METRO RED LINE, SEGMENT 2, CONTRACT B251

Investigation of Tunnel Collapse and Sinkhole

FINAL REPORT

WJE No: 951473

TYPICAL STEEL SET

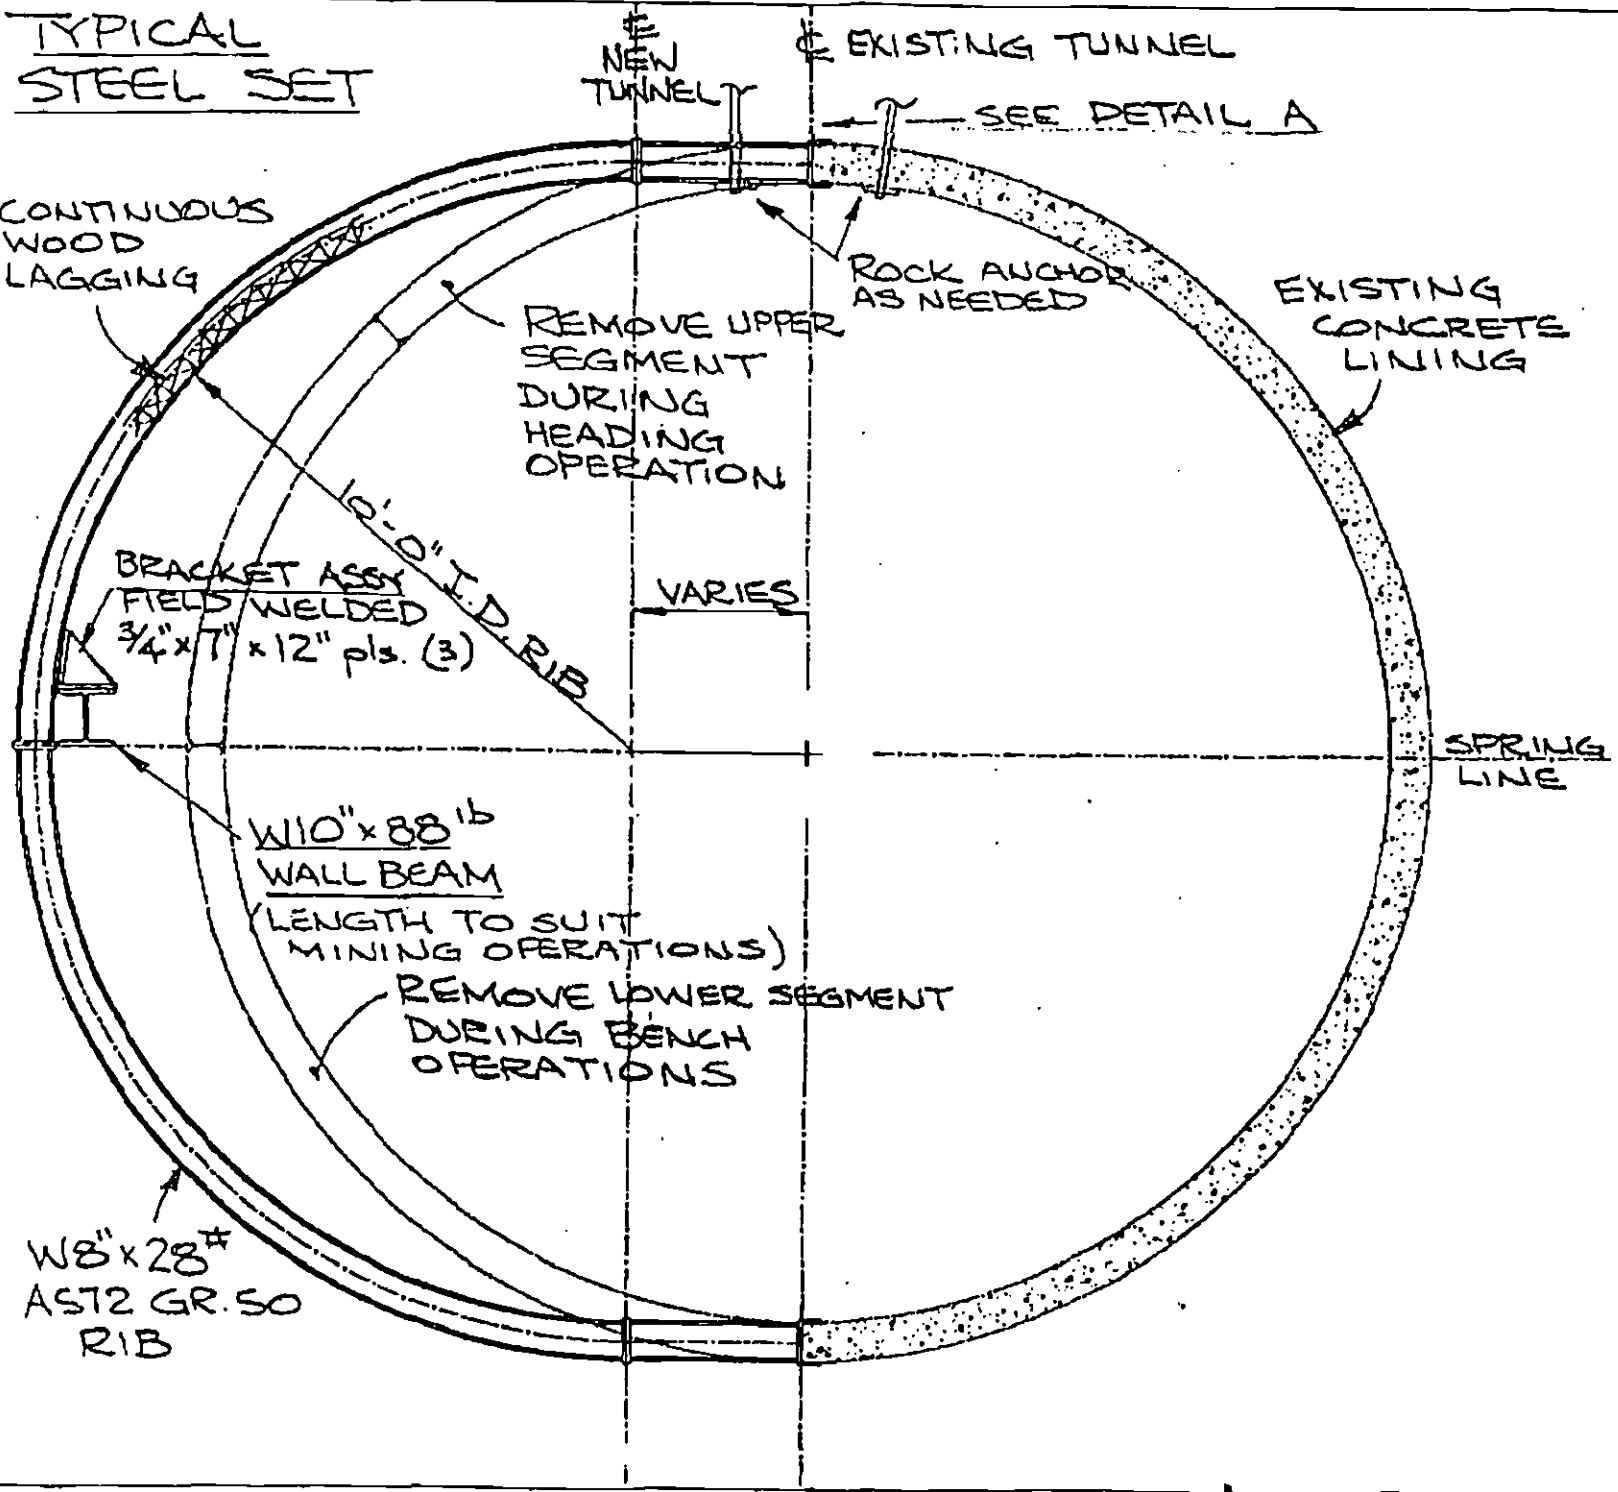
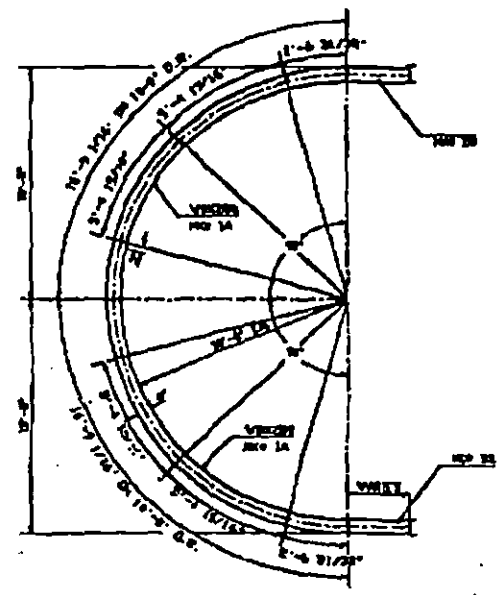
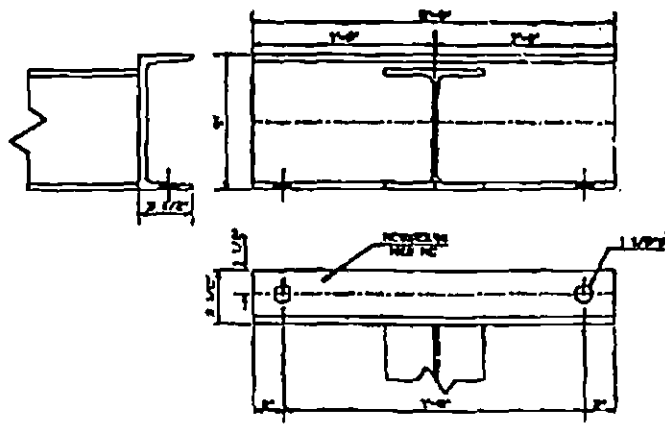
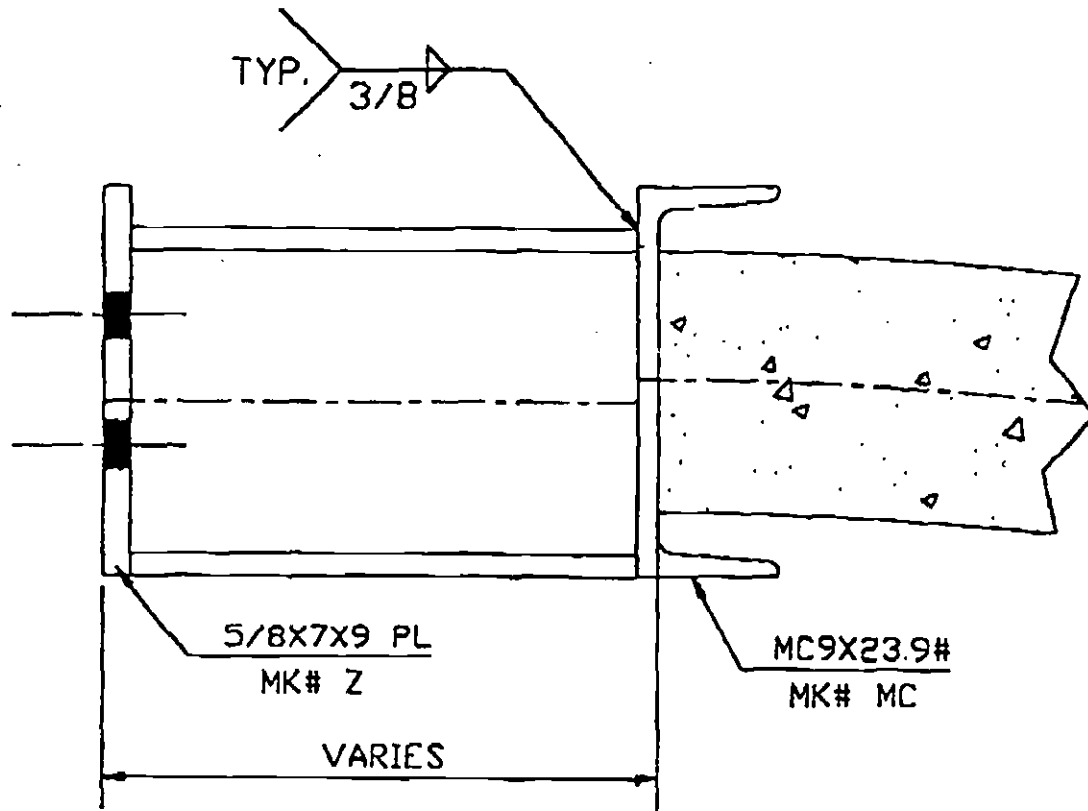
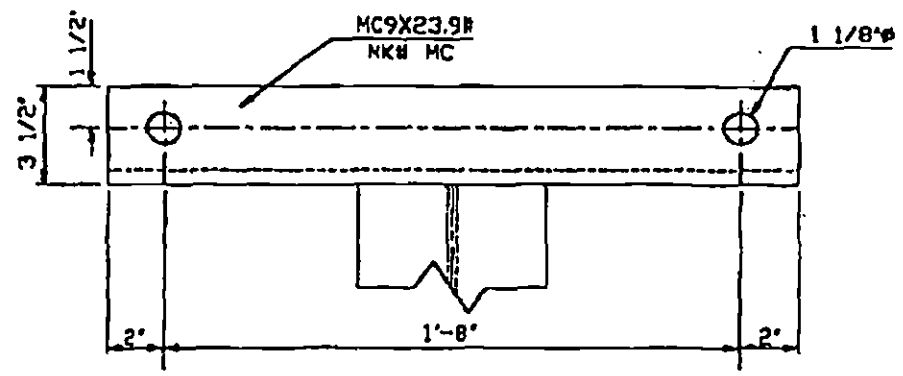
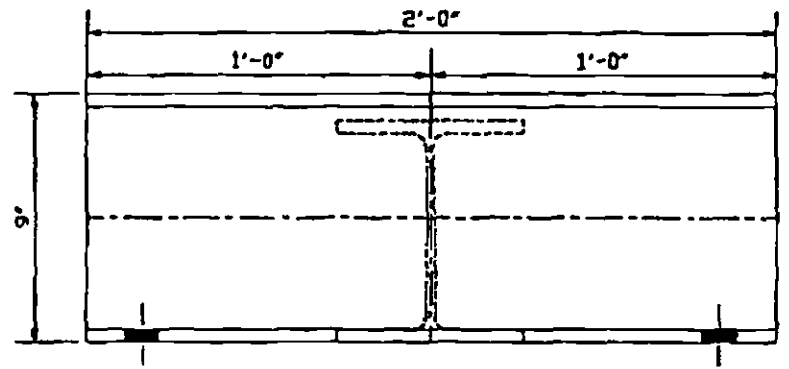
1. The design is appropriate if only horizontal remining and resupport is required. Quick review of the remining cross-sections indicate remining will require section with vertical offset as well for which such a scheme is not appropriate. Provide details for the full range of conditions encountered.

2. The precast concrete segment design load differs greatly from that used by the structural steel designer (Commercial). The two designs must be compatible. It appears the structural steel ribs would be adequate, provided bearing plates and details are sized accordingly but the wall plate and intermediate support details will require modification.

3. No calculations are provided for the rock anchors. Please provide calculations and details.
4. These details are appropriate for sections wholly with Puente.

5. Mining of such a section require careful control of excavation and control of ground. Provide detail excavation sequence, intermediate support details and face stability methods.

6. Provide post and foot plate design and bearing capacity calculations.

This submittal lack primary calculations and necessary support details which are critical to the safe execution of this remining operation. Please provide these details and calculations for review and approval.

- (1) The design presented in this submittal is for horizontal remaining only. If other conditions are encountered, an appropriate submittal shall follow.
- (2) The calculations have been revised to show the compatibility of the steel rib design and the precast concrete segment design. The intermediate supports have been redesigned as shown in the calculations.
- (3) Calculations for rock anchor capacities have been submitted in the previous approved submittal B251-02312-1.5-5.00. A copy is provided for your reference.
- (4) The proposed submittal is designed only for sections completely within puente. If other conditions are encountered, an appropriate submittal shall follow.
- (5) For a detailed excavation sequence, see construction sequence in calculations.
- (6) For post and foot plate design and bearing capacity calculations, see calculations.

TYPICAL STEEL SET

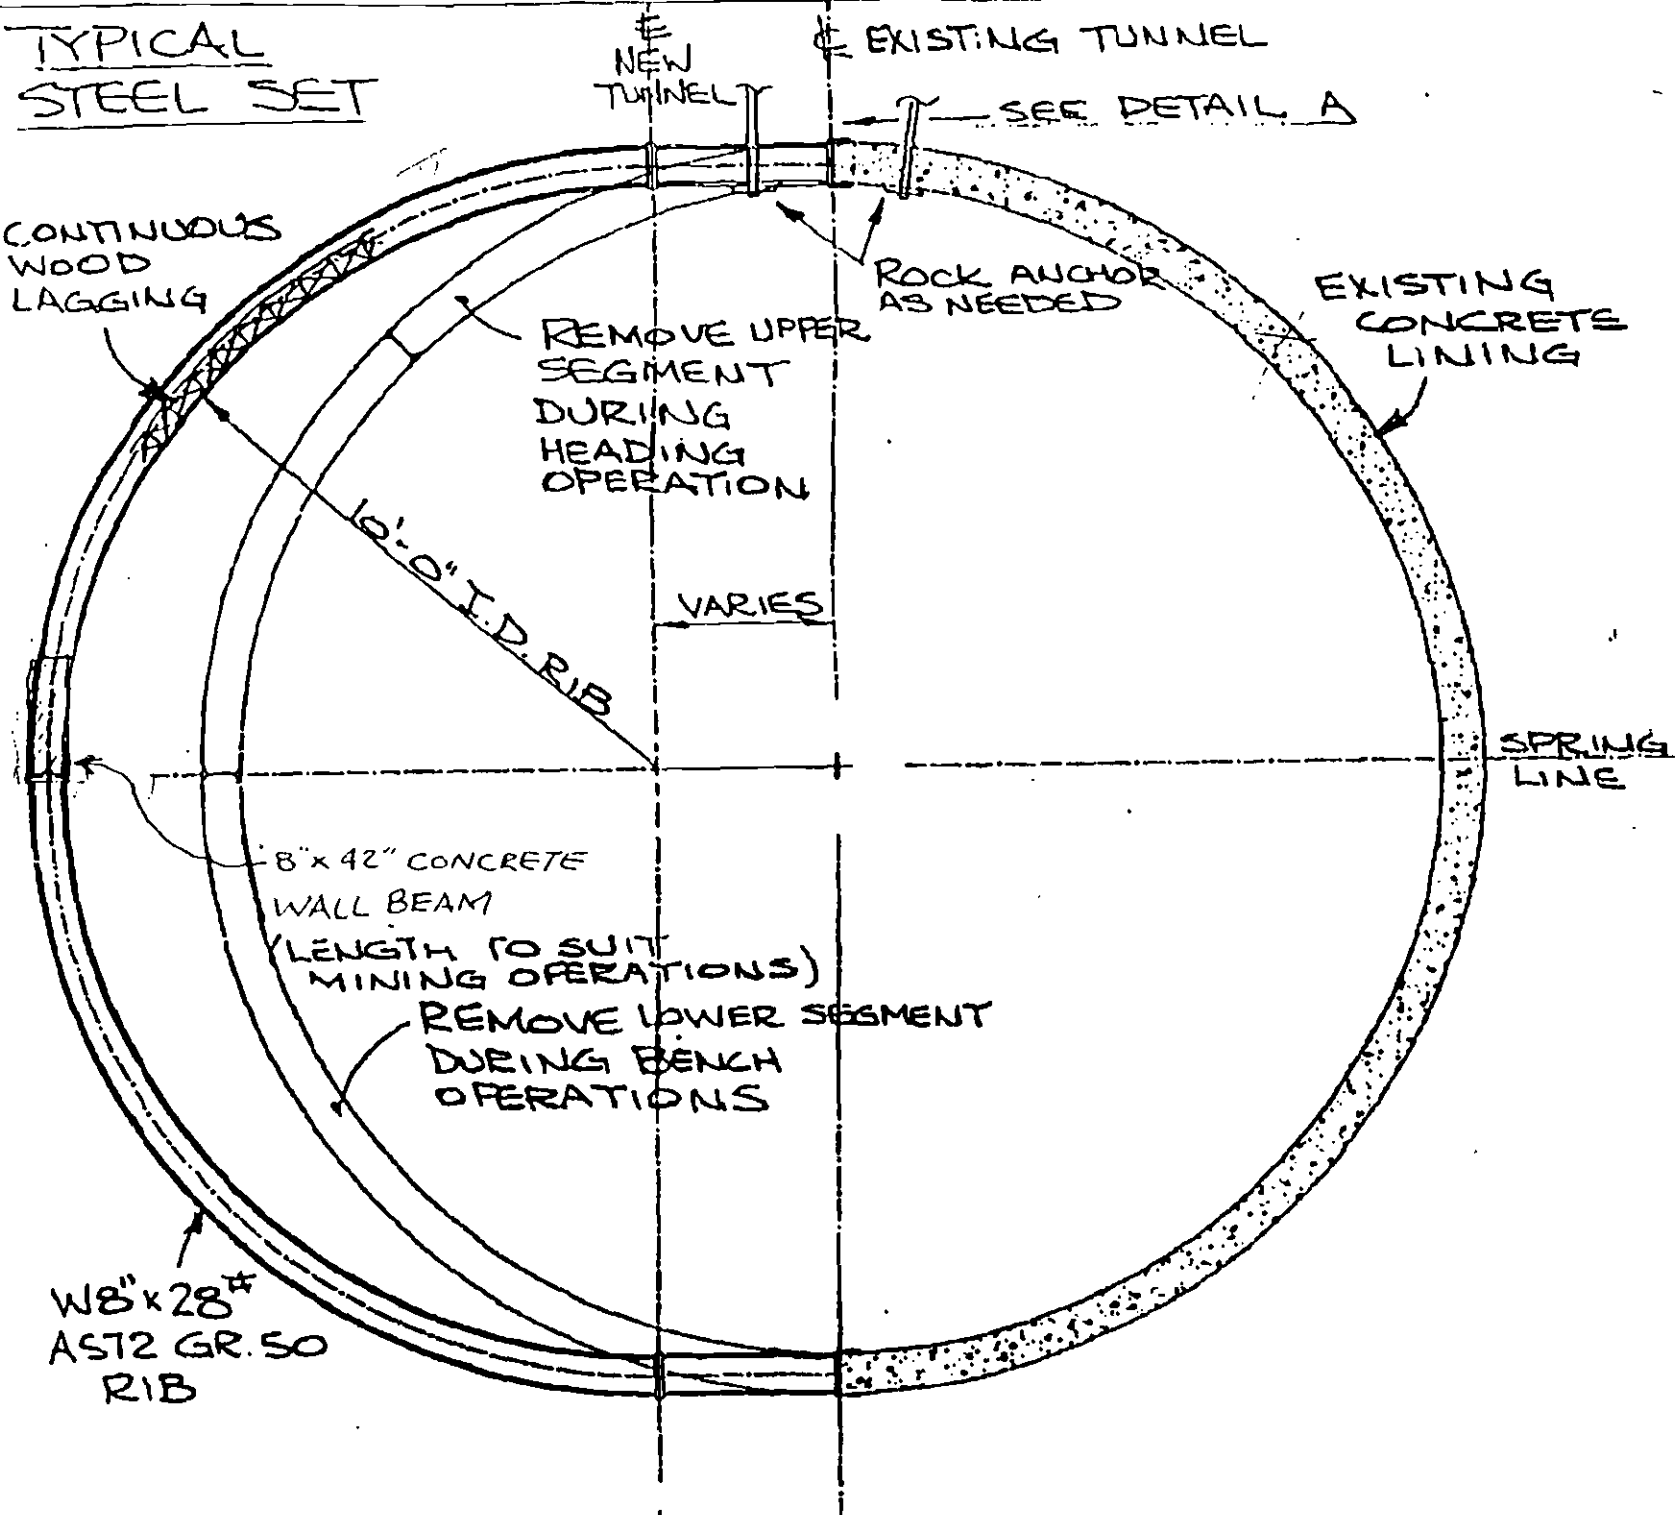
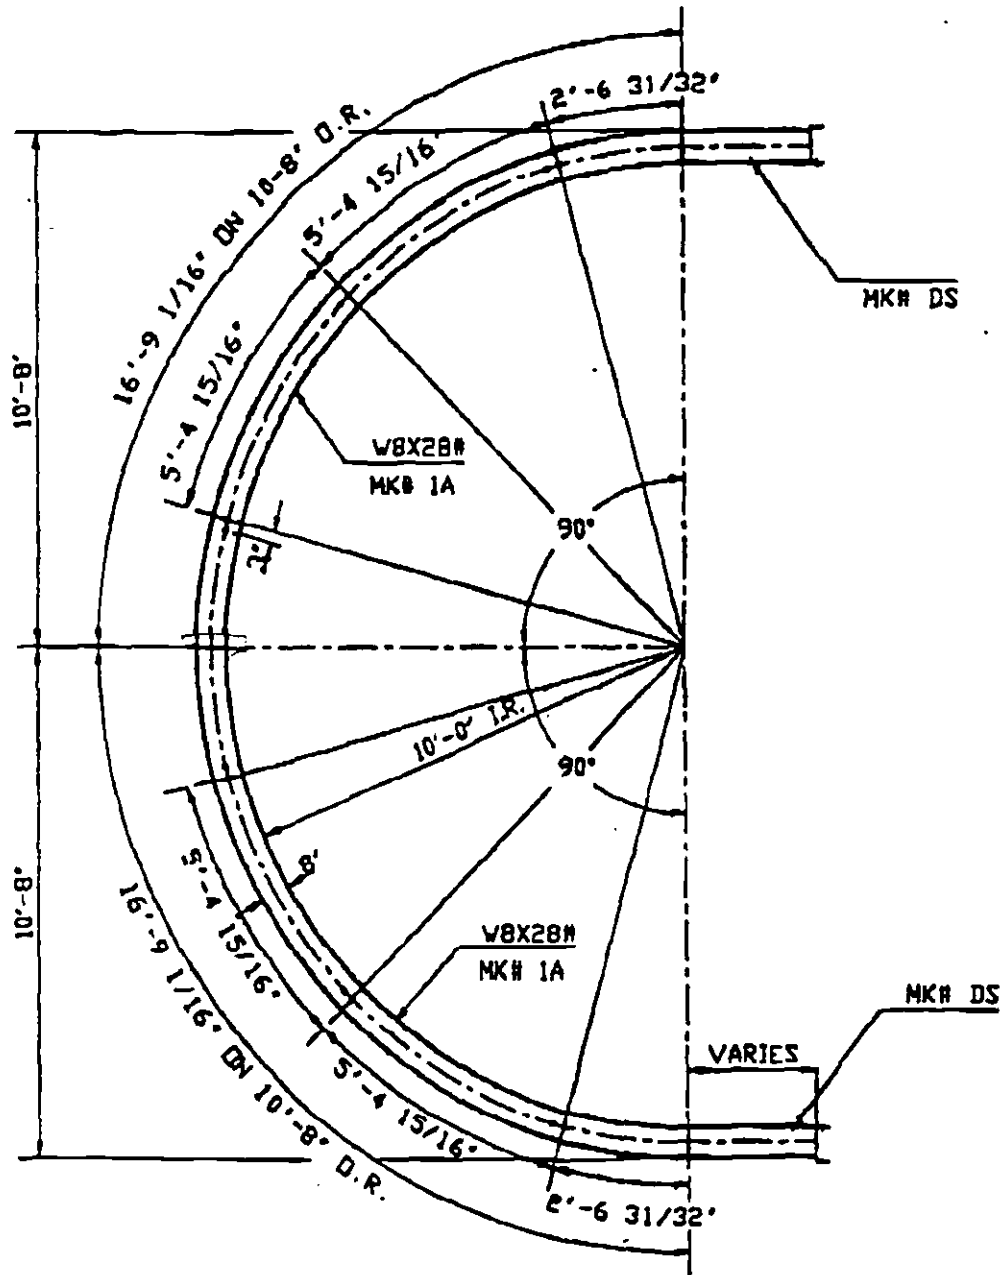
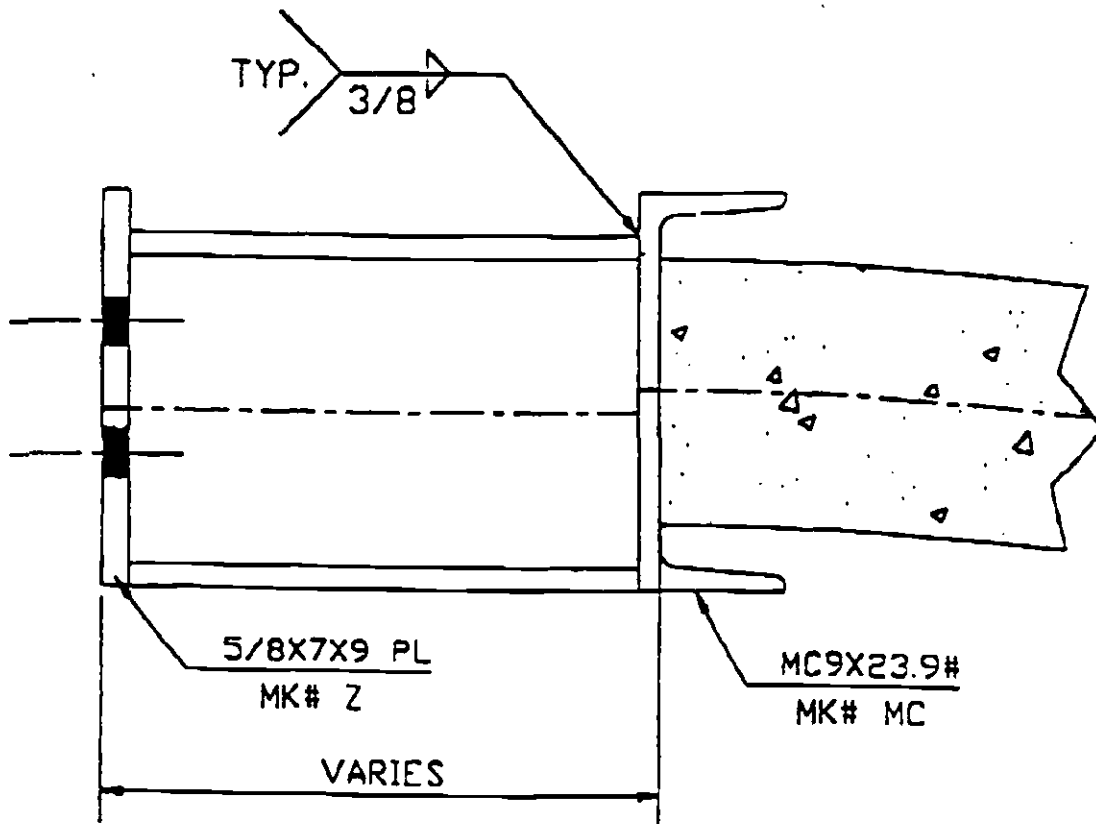
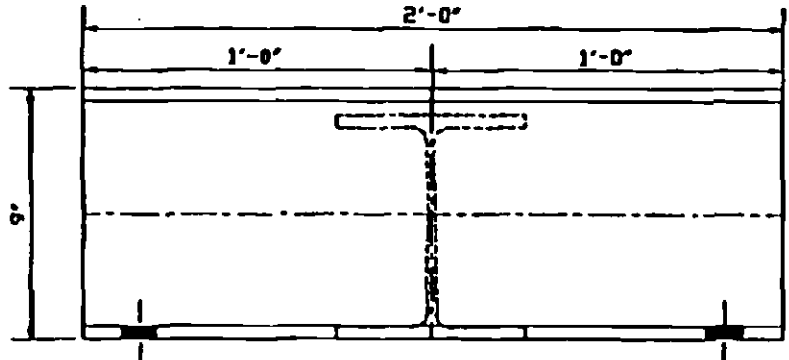
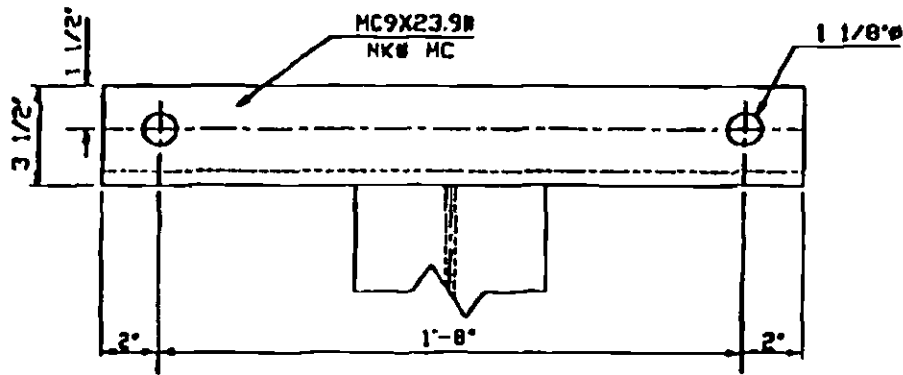
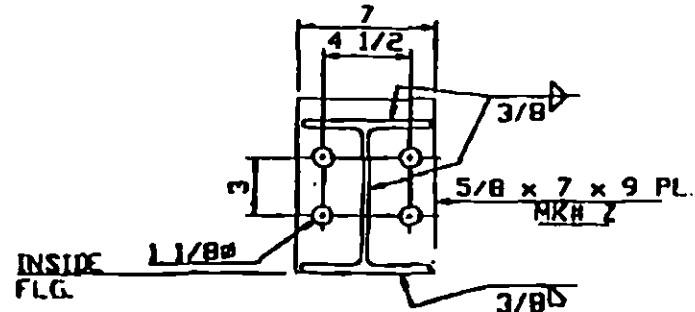
1. The design is appropriate if only horizontal reining and resupport is required. Quick review of the reining cross-sections indicate that reining will require sections with vertical offsets as well, for which such a scheme is not appropriate. Provide details for the full range of conditions encountered.

2. The precast concrete segment design load differs greatly from that used by the structural steel designer (Commercial). The two designs must be compatible. It appears the structural steel ribs would be adequate, provided bearing plates and details are sized accordingly, but the wall plate and intermediate support details will require modification.

3. No calculations are provided for the rock anchors. Please provide calculations and details.
4. These details are appropriate for sections wholly within Puente.

5. Mining of such a section requires careful control of excavation and control of ground. Provide detailed excavation sequence, intermediate support details and face stability methods.

6. Provide post and foot plate design and bearing capacity calculations.

This submittal lacks primary calculations and necessary support details which are critical to the safe execution of this reining operation. Please provide these details and calculations for review and approval.
